iCAROS phase 1 REX

11 December 2024

Agenda

Issue 1

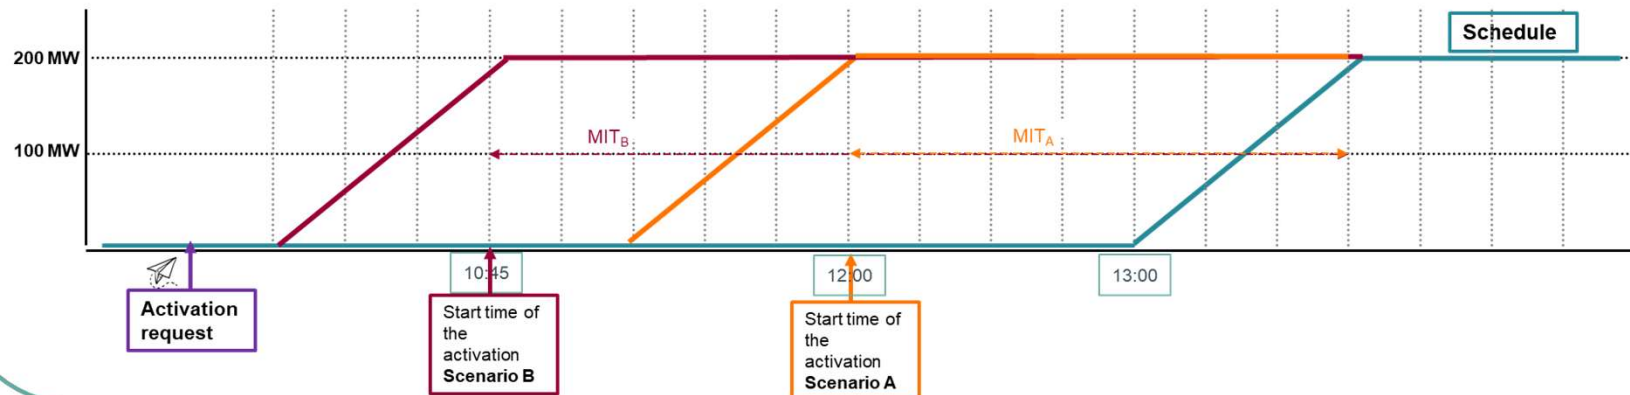
Issue with Minimum Activation Time (MIT) currently defined at the timeseries level

During start-up / shut-down, not possible/easy way with the current properties to offer the full flexibility

- Unit schedule starts-up at 13:00
- For congestion issue, Elia needs to start-up the unit earlier:
 - Scenario A at 12:00 => Minimum Activation Time = 1h
 - Scenario B at 10:45 => Minimum Activation Time = 2h15

→ Definition of MIT properties at bid level with a 15min granularity (similar as Maximum Energy Level (MEL))

Implementation
in Q2/Q3 2025

Issue 2

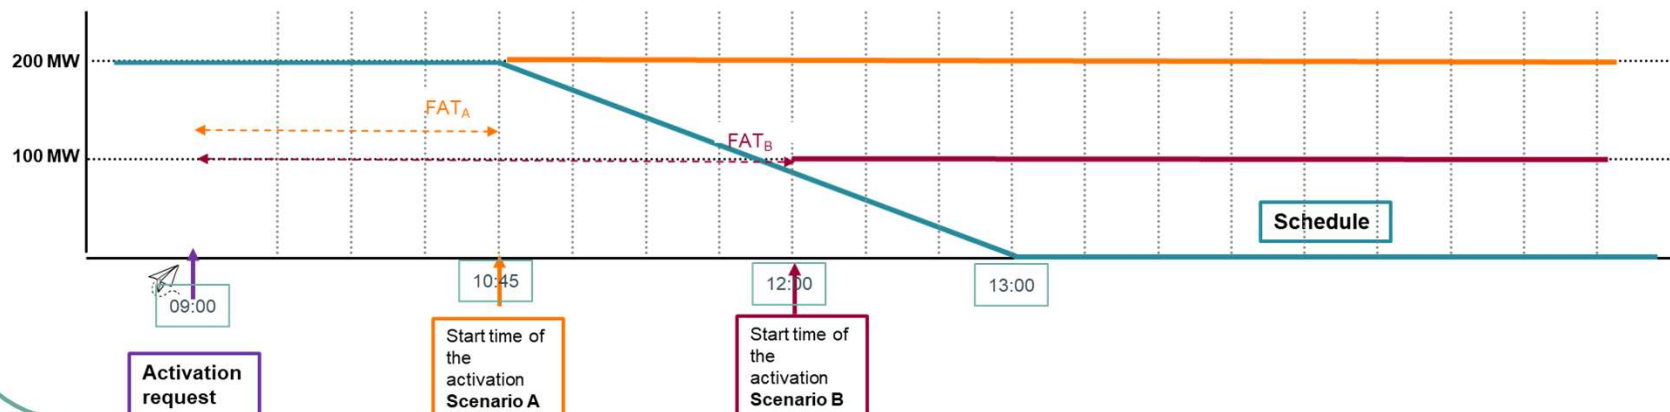
Issue with Full Activation Time (FAT) currently defined at the timeseries level

During start-up / shut-down, not possible/easy way with the current properties to offer the full flexibility

- Unit schedule starts a slow shut-down at 10:45
- At 9am, for congestion issue, Elia needs avoid the shut-down
 - Scenario A when the unit start the ramp-down to keep at Pmax
 - Scenario B when the unit has already started the ramp-down to keep the unit at Pmin

$FAT_A \neq FAT_B$

→ Definition of FAT properties at bid level with a 15min granularity (similar as Maximum Energy Level (MEL))

Implementation
in Q2/Q3 2025

Issue 3

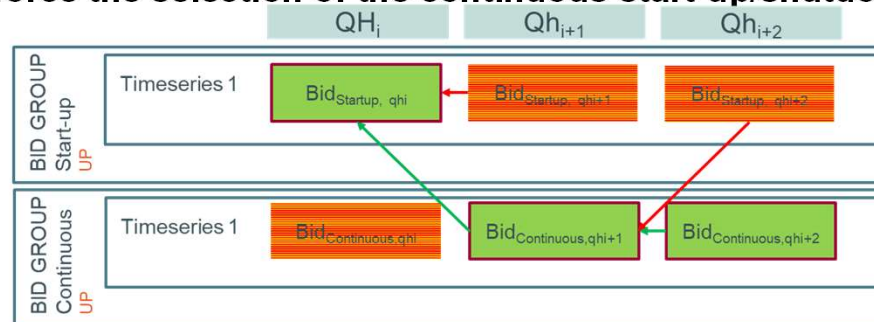
Issue with start-up / shut-down to force the selection of the continuous start-up/shutdown bids with MIT

2 Bid Groups to reflect start-ups:

- **Start-up bids**
 - initially **available**
 - Becomes **unavailable** if Bid_{Startup, qh-1} is activated: **A55 link**
 - Becomes **unavailable** if Bid_{Continuous, qh-1} is activated: **A55 link**
- **Continuous bid**
 - is initially **unavailable**
 - **Has a MIT**
 - Becomes available if Bid_{Startup, qh-1} is activated: **A67 link**
 - Or Becomes available if Bid_{Continuous, qh-1} is activated: **A67 link**

→ Creation of new conditional links specific for start-ups/shut-downs (ie A95 to use additionally for the start-up bid)

A95: bid (start-up) initially available,

- becomes unavailable if linked bid (Continuous) is not activated in qh+1
